## **Access Compliance Report Public Rights-of-Way** (Curb Ramps)

Main Street: NARROW CANYON RD **Cross Street: O NEILL DR** Location: ADA ID: RPRK211027124744 Ramp Type:Type 1 - Perpendicular Initial Pass/Fail: Fail **Overall Compliance: No Severity Score:** 15

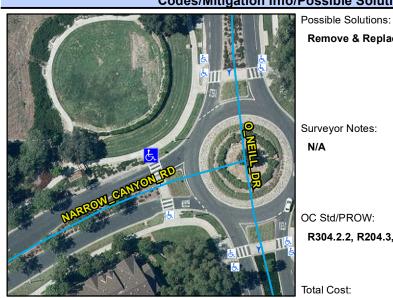
R304.2.2, R204.3, STD 1115

Field Measurements/Component Compliance										
	Compliance Description			Com	pliance Description	Data				
	N/A	Ramp Length (in)	108	N/A	Flare Type LT					
	Yes	Ramp Width (in)	48			N/A				
	No	Ramp Run Slope (%)	10.6	N/A	Flare Slope LT (%)	N/A				
	Yes	Ramp Cross Slope (%)	0.6	N/A	Flare Traversable LT	N/A				
	N/A	Landing Present	N/A	N/A	Flare Type RT					
	N/A	Landing Length (in)	N/A			N/A				
	N/A	Landing Width (in)	N/A	N/A	Flare Slope RT (%)	N/A				
	N/A	Landing Run Slope (%)	N/A	N/A	Flare Traversable RT	N/A				
	N/A	Landing Cross Slope (%)	N/A	N/A	DWS Provided	N/A				
	N/A	Landing Movement Obstructed?	N/A	N/A	DWS Contrast	N/A				
		Landing Movement Type	N/A	N/A	DWS Length (in)	N/A				
	N/A	Landing Shared	N/A	N/A	DWS Full Width	N/A				
	N/A	Clear Space	N/A	N/A	DWS Offset Left (in)	N/A				
	N/A	Clear Space To Crosswalk (in)	N/A	N/A	DWS Offset Right (in)	N/A				
\$ 3080	N/A	Marked Crosswalk 1	Yes	N/A	Marked Crosswalk 2	N/A

Remove & Replace Entire Ramp.
